Access Compliance Report

Public Rights-of-Way

(Island Curb Cuts)

Intersection ID: 17298	Main Street: IDLEWILD_RD	Cross Street: NEW_HAMPSHIRE_DR	Location: SE
ADA ID: 0480B5E4B8AC	Curb Cut Type: MedianRefuge2	Initial Pass/Fail: Fail	Overall Compliance: No
Codes/Mitigation Info/Possible Solution		Field Measurements/Component Compliance	
Severity Score: 1.25

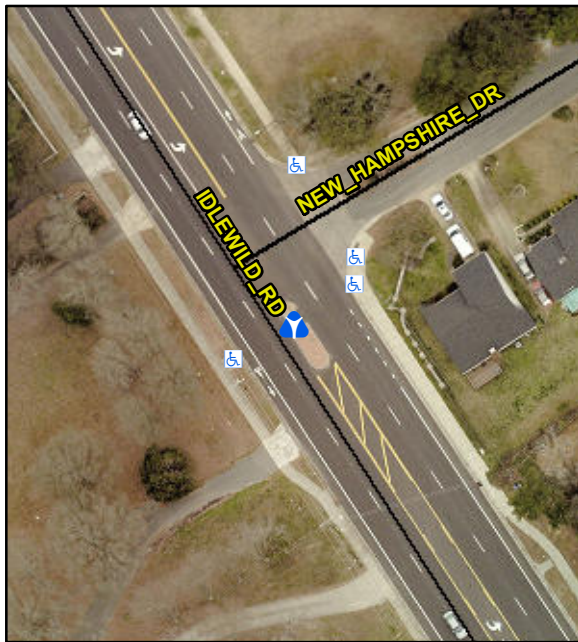
Remove & Replace Entire Refuge.
